<b>Licence Number</b>	L8904/2015/1
<b>Licence Holder</b>	Cleanaway Solid Waste Pty Ltd
<b>ACN</b>	120 175 635
<b>File Number:</b>	DER2015/001648-1
<b>Premises</b>	<p>Banksia Rd Landfill Site 2 Banksia Rd Crooked Brook WA 6236</p> <p>Legal description – Lot 2 on Deposited Plan 65861 Certificate of Title Volume 1670 Folio 568 As depicted in Schedule 1 of L8904/2015/1</p>
<b>Date of Report</b>	17 December 2019

# 1. Amendment Description

## 1.1 Purpose and scope of assessment

**Figure 2: Noise contour plot**

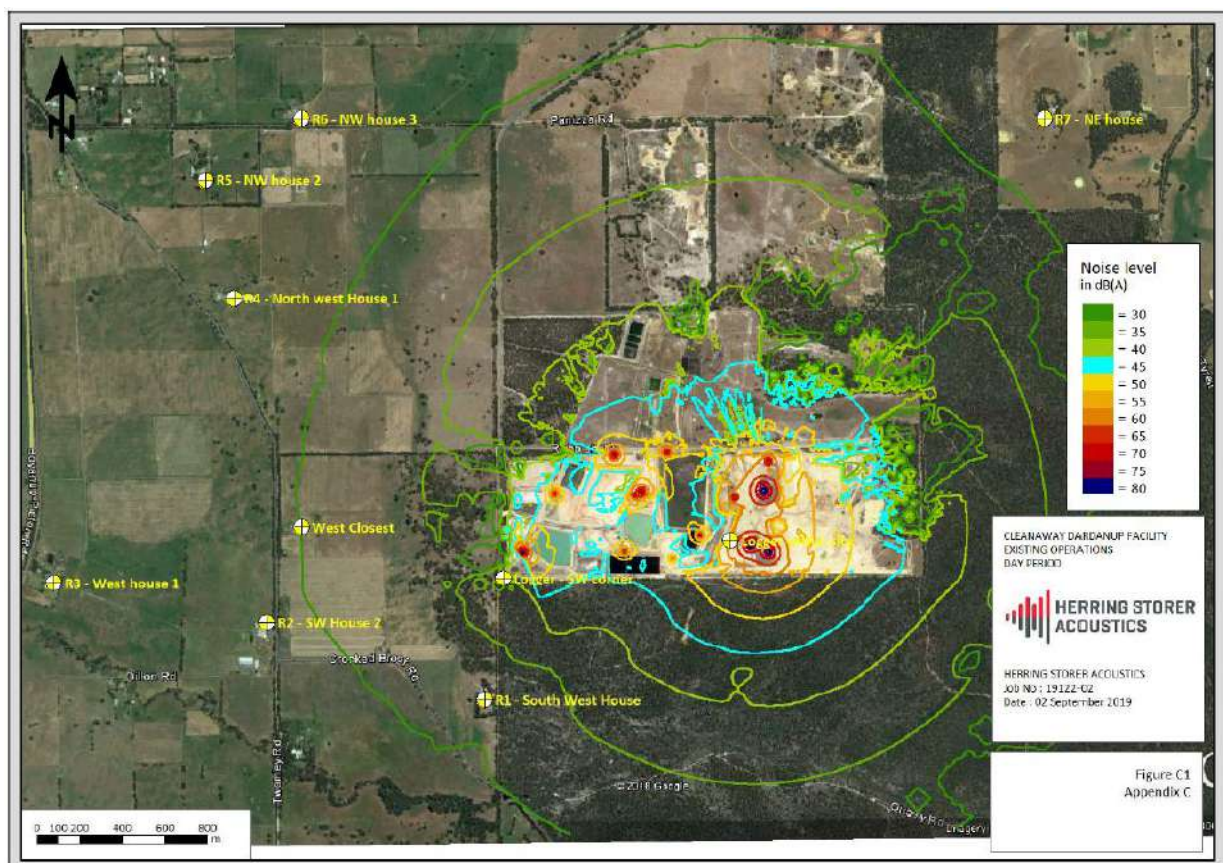
Technical review of the assessment undertaken by DWER indicates that noise compliance at the closest noise sensitive premises was not demonstrated by measurement; rather based solely on the predictions made by noise modelling. The review also identified that further

information was required to adequately assess the methodology of the Herring Storer noise modelling.

1. The Herring Storer Acoustics *Environmental Acoustic Assessment* indicated that whilst noise emissions from the facility will comply with the requirements of the *Environmental Protection (Noise) Regulations 1997* at all times, predicted noise levels were exactly at assigned levels at certain periods and at certain locations.
2. Advice from DWER Environmental Noise section following technical review of the Herring Storer Acoustics *Environmental Acoustic Assessment* (assessment) and subsequent requested information agreed with the findings of the *Environmental Acoustic Assessment* that the proposed waste acceptance increase will not impact noise emission levels from the Premises.
3. Advice from DWER Environmental Noise section is that compliance of an existing operation should be demonstrated by noise measurement at noise sensitive premises, rather than by noise modelling.

Further information regarding the assessment was requested by DWER on 12 November, with the Licence Holder providing the requested information on 14 November 2019 (Cleanaway, 2019c). This information provided further clarification of variables within the noise modelling calculations and reasoning for the methodologies undertaken.
